**TYPE III – PLANNING COMMISSION
STAFF REPORT AND RECOMMENDATION
November 16, 2018**

FILE NUMBER: GLUA-18-00025
VAR-18-00001
SP-18-00106
MD-18-00001 (of CU 14-01)

REQUEST: Minor Site Plan and Design Review, Modification to Conditional Use CU 14-01,
Minor Variance for a 7-Bed Expansion to a 31-Bed Assisted Living Memory Care
Facility at the NW corner of Amanda Court and South End Road

LOCATION: 950 South End Road, Oregon City, OR 97045
Clackamas County Map 3-1E-01AD, Tax Lot 3100

Figure 2: Proposed Site Plan – Not to Scale

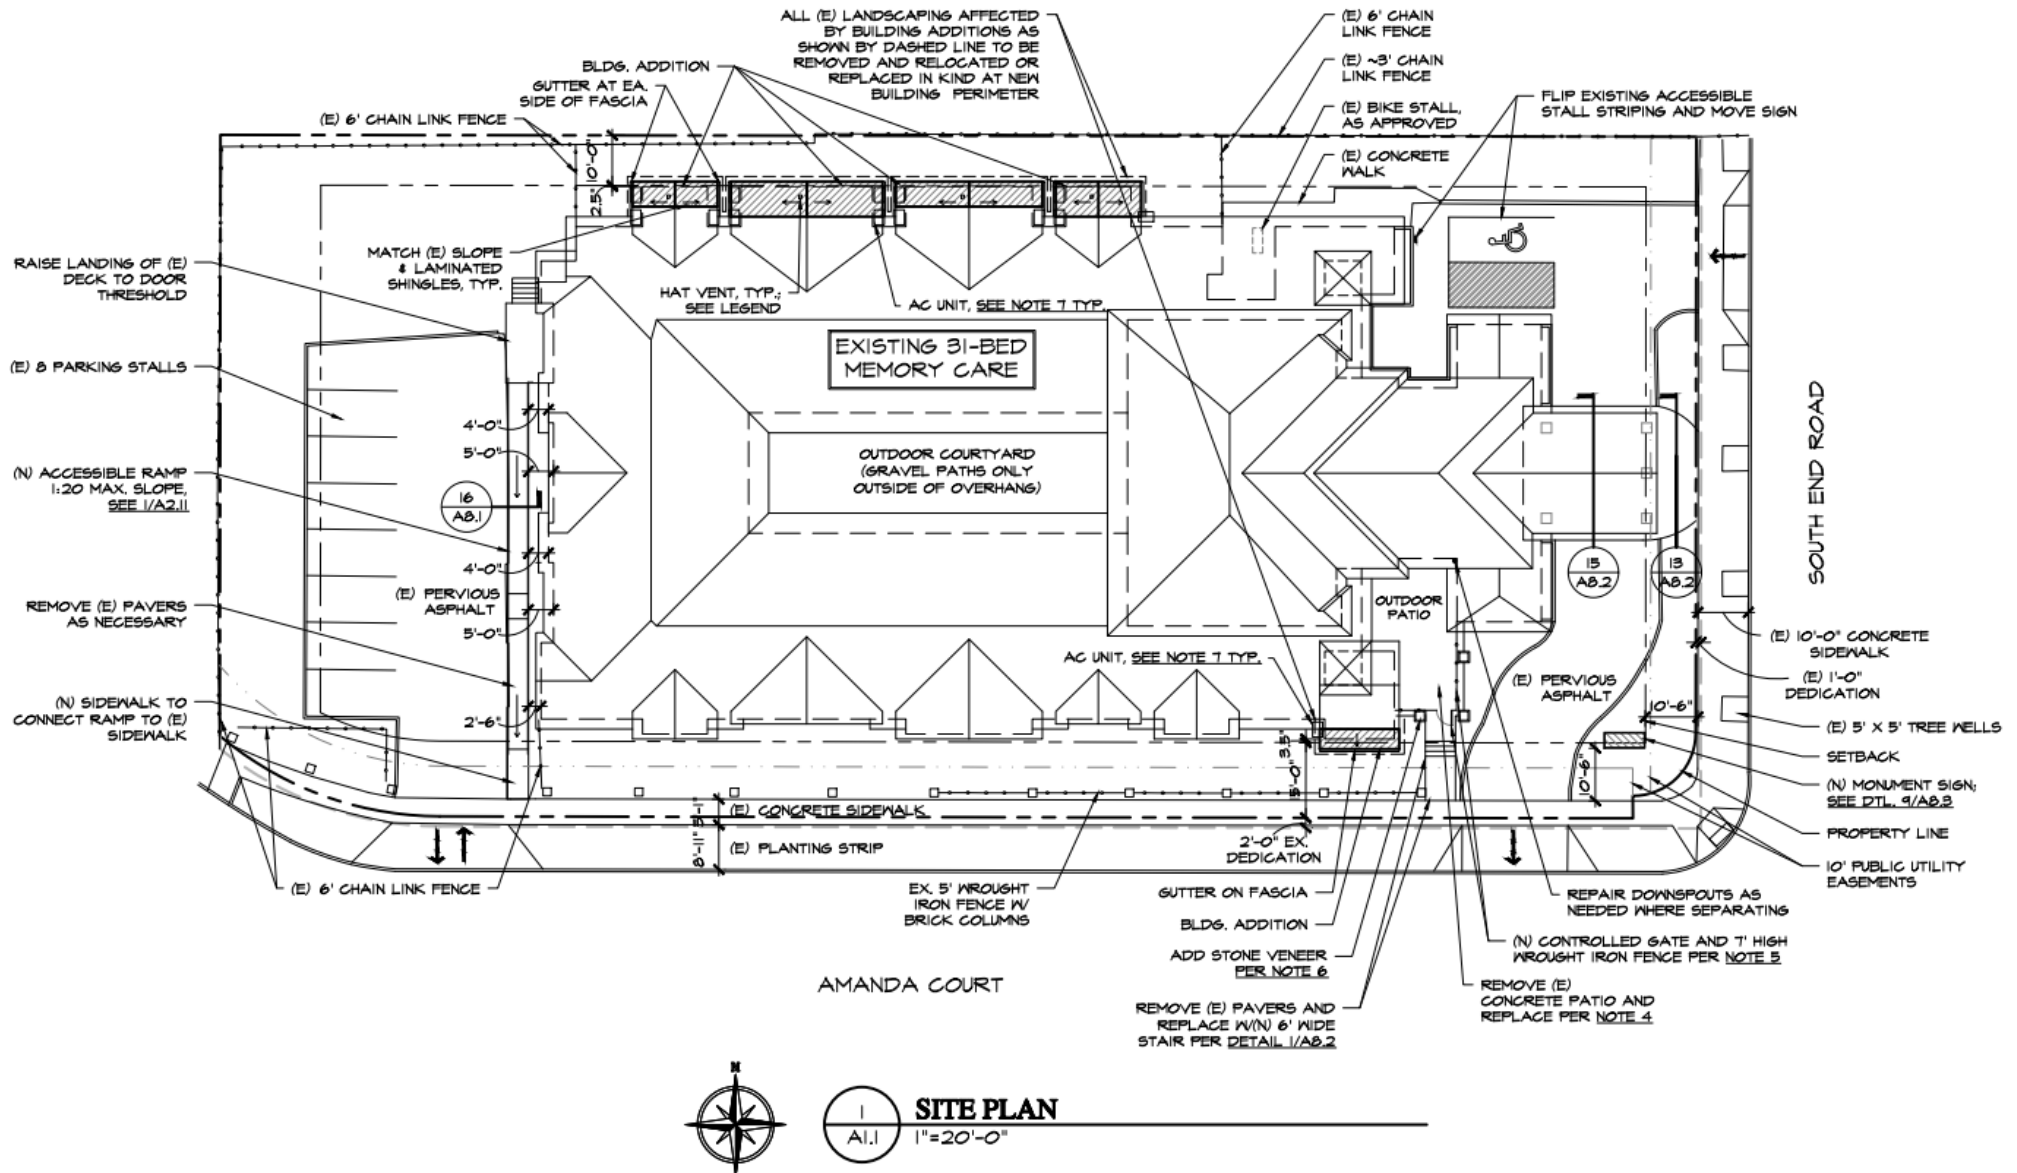
The proposed hardscape pathways on the south and north sides of the building appear to be less than five feet wide. Pathways are not required around the entire building in order to comply with this section due to the sidewalk connection, however, since they are proposed, they are required to be at least five feet in width. Therefore, prior to issuance of a building permit, the applicant shall either remove the on-site paths which are not required that are less than five feet in width on plan submittals or revise the plans to indicate 5' wide paths and widen the required pathways to 5 feet. Because the building fronts on the street, the existing sidewalk may be used to meet this standard. **Staff has determined it is possible, likely and reasonable the applicant can meet this standard by complying with the recommended conditions of approval.**

1. Width of on-site pathways. Prior to issuance of a building permit, the applicant shall either remove the on-site paths that are less than five feet in width on plan submittals, or revise the plans to indicate 5' wide paths in accordance with OCMC 17.62.050.A.9. For buildings fronting on the street, the public sidewalk may be used to meet this standard. (P)

Figure 5: Proposed Modifications to North Elevation – Not to Scale

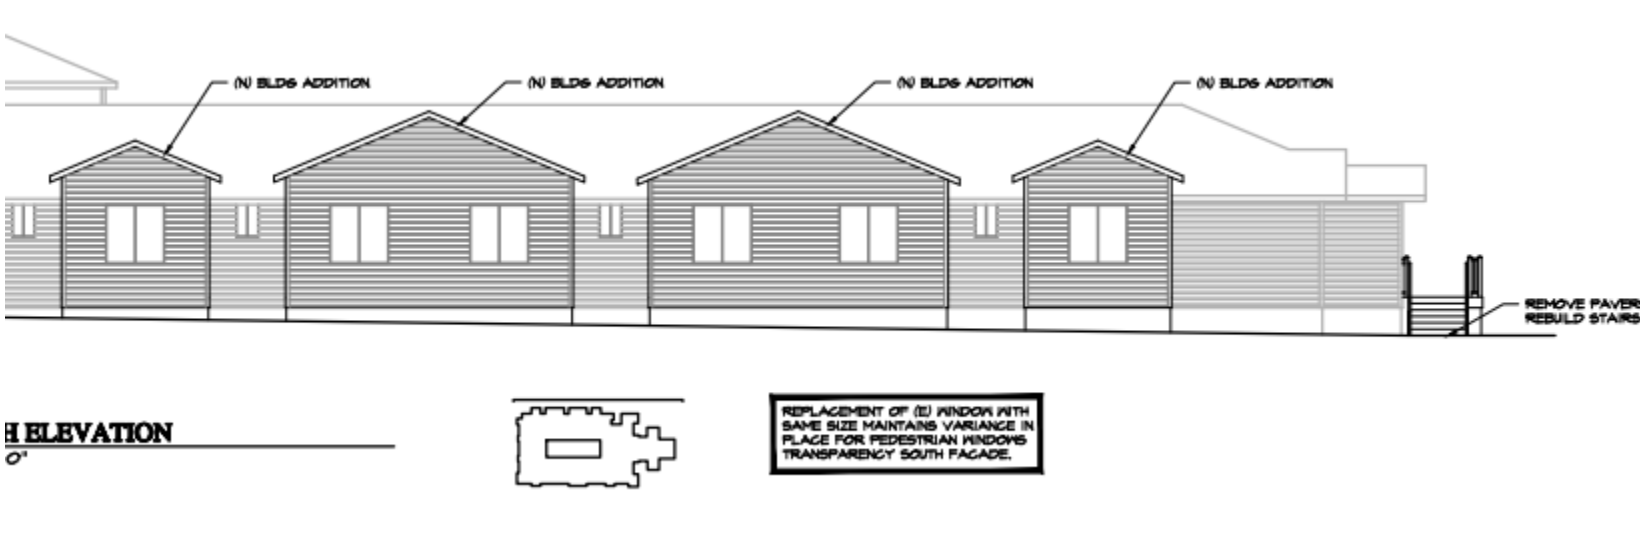
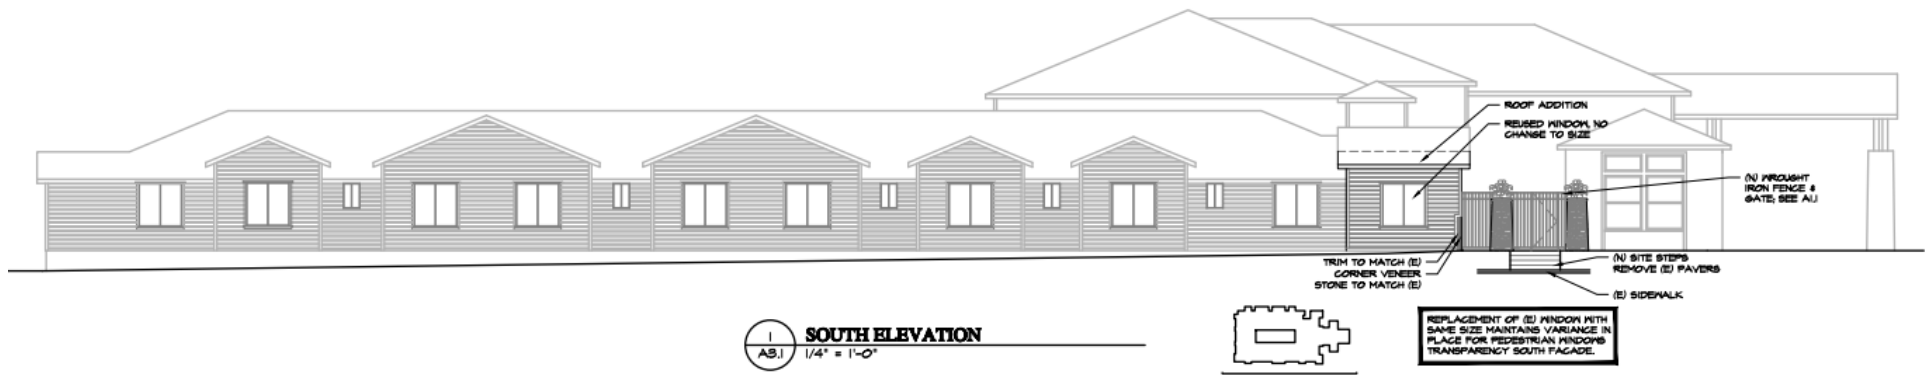
The bedroom addition to the southeast corner will bump out the wall an additional four feet from the existing wall plane. The six bedroom additions to the northwest corner will increase the existing wall articulations by five feet in order to accommodate the additional bed spaces for six of the rooms on the northwest side, however, that side of the building does not face the street.

Figure 6: Proposed Modifications to South Elevation – Facing Amanda Court – (Not to Scale)

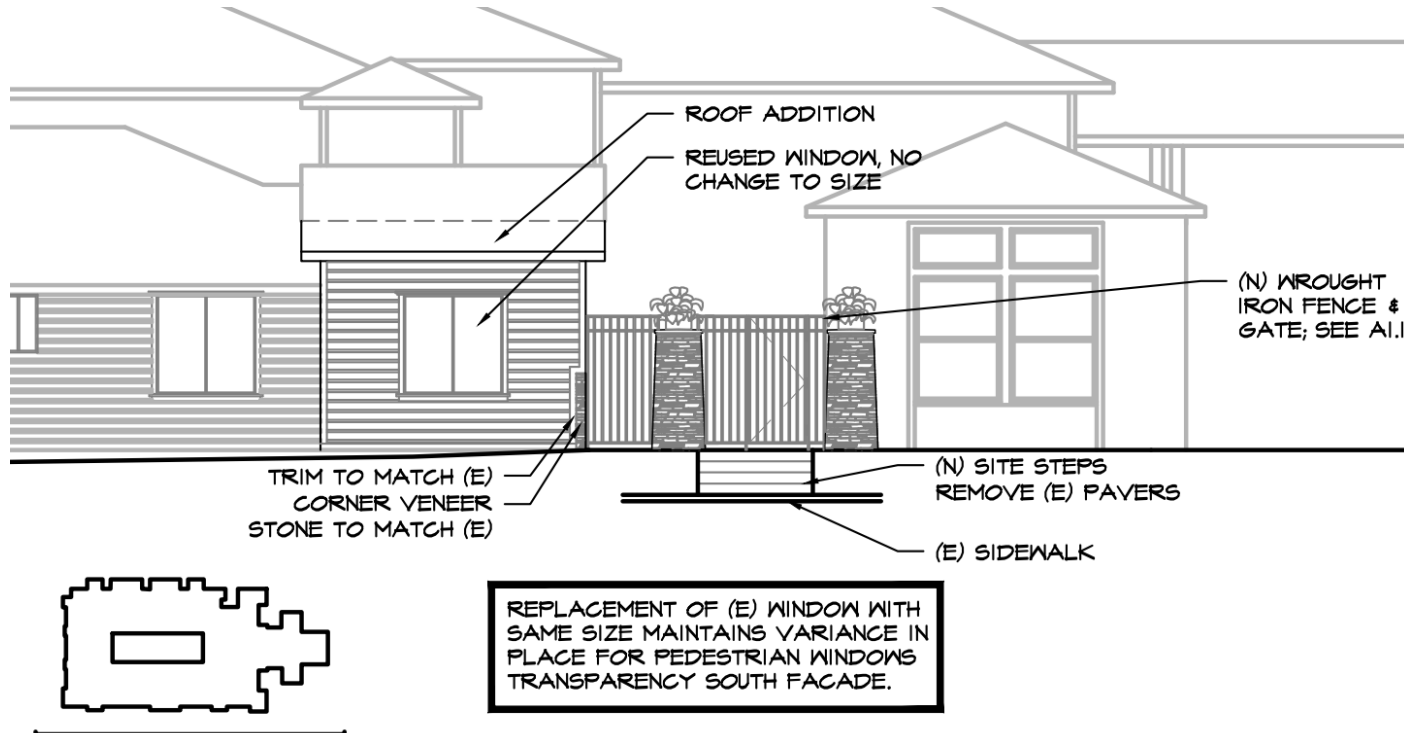
An email comment from Gregory Peterson regarding the screening requirements for ground mounted mechanical equipment. Mr. Peterson stated that several air-conditioning units on the south exterior are not properly shielded from view, as required by OCMC 17.62.050.A.20.C.

comment was received regarding the screening requirements for ground mounted mechanical equipment. According to the comment, several air-conditioning units on the south exterior are not properly shielded from view. Prior to issuance of a building permit, the applicant shall provide ornamental fences, screening enclosures, trees, or shrubs that block at least eighty percent of the view of the mechanical units from the street. **Staff has determined it is possible, likely and reasonable the applicant can meet this standard by complying with the recommended conditions of approval.**

5. Screening for mechanical equipment. Prior to issuance of a building permit, the applicant shall provide ornamental fences, screening enclosures, trees, or shrubs that block at least eighty percent of the view of the mechanical units from the street in accordance with OCMC 17.62.050.A.20. (P)
